Modification Notice - Regulation 22

Interest Holder	Santos QNT Pty Ltd	EMP Title	Dukas-1 - Conventional Gas Well, EP 112 and 125	Unique EMP ID No.	STO-2019	Change/Mod No.	3	Date	17/02/2026
Brief Description	This modification to the EMP allows for a revised access track alignment to avoid a recently expanded Aboriginal Areas Protection Authority (AAPA) exclusion zone. The revised access track alignment avoids areas of ecological or cultural heritage significance. Existing mitigation measures in the EMP remain applicable and will ensure impacts are minimised.								
Geospatial Files Included?	No								
Does the proposed change result in a new, or increased, potential or actual environmental impact or risk?	If an INCREASE in an existing potential or actual environmental impact or risk, is it provided for in the approved EMP?	Does the proposed change require additional mitigation measures to be included?	Has additional stakeholder engagement been conducted?	Does it require additional environmental performance standards and measurement criteria?	Does it affect compliance with Sacred Site Authority Certificates?	Does it affect current rehabilitation, weed, fire, wastewater, erosion an

Figure 4-1: Proposed Access Track Realignment

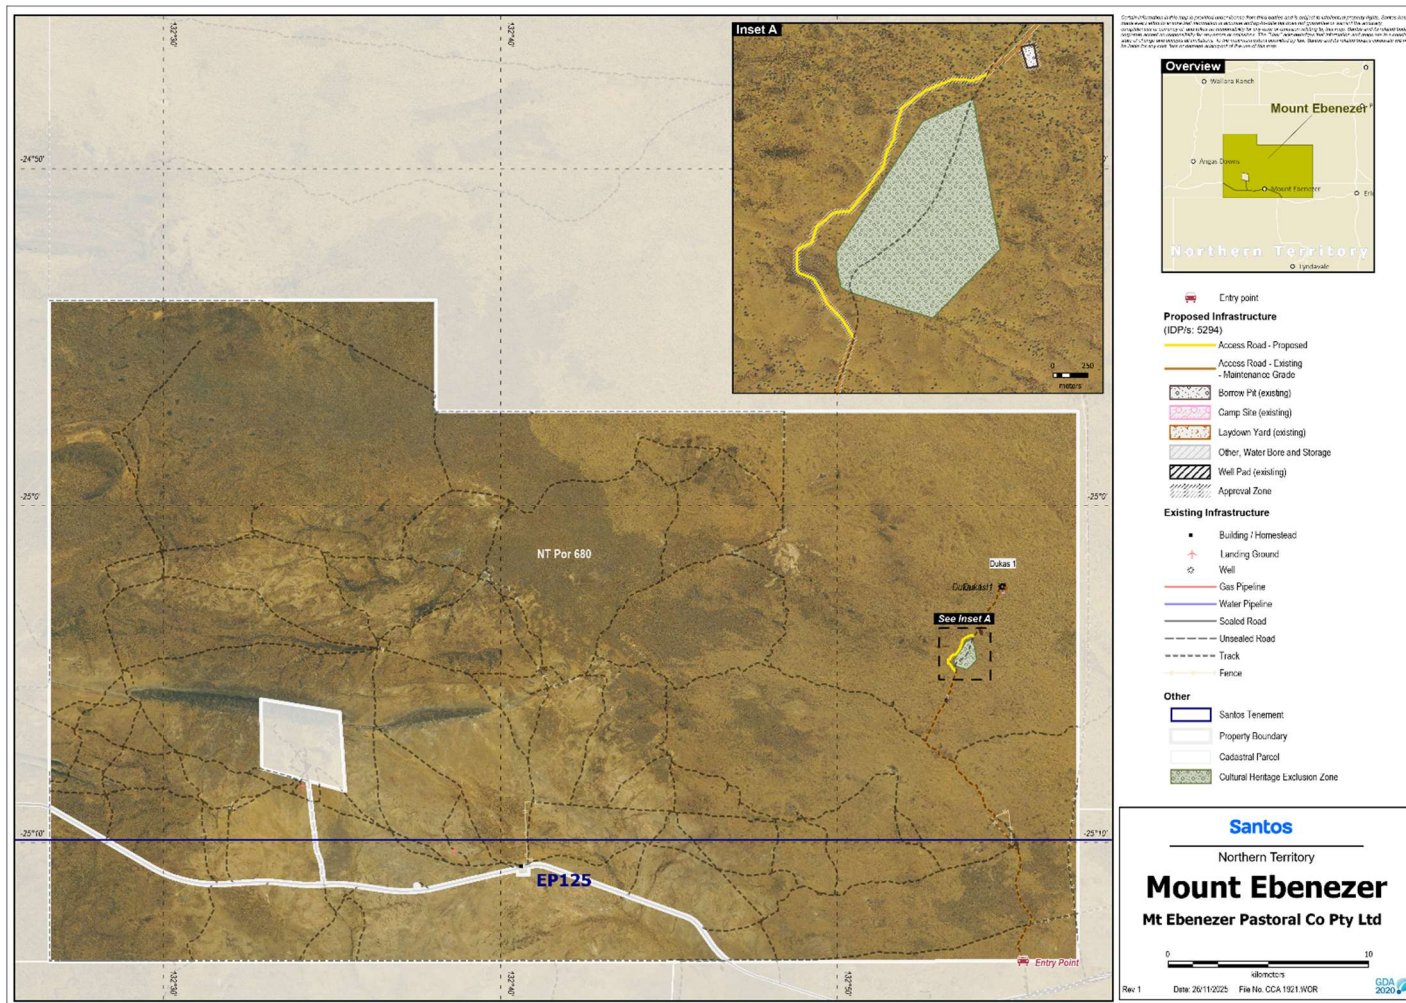
<p>Additionally, the AAPA cultural heritage exclusion zone located approximately 4.8 km south-west of the Dukas-1 well pad has recently been expanded to include a section of the existing landholder access track. A new CLC certificate was issued on 27 March 2025 (C2022-154) that includes a condition that Santos are not to utilise the existing access track within the revised Cultural Heritage Exclusion Zone. A revised access track alignment of approximately 3 km has been scouted to the west of the existing track to avoid the exclusion zone. The proposed access track realignment passes through land that was subject to a cultural heritage pre-clearance survey and ecological survey in 2018 and 2023 respectively, and does not impact any areas of cultural or ecological significance. Refer to Figure 4-1 for the location of the proposed access track realignment.</p>
--	---
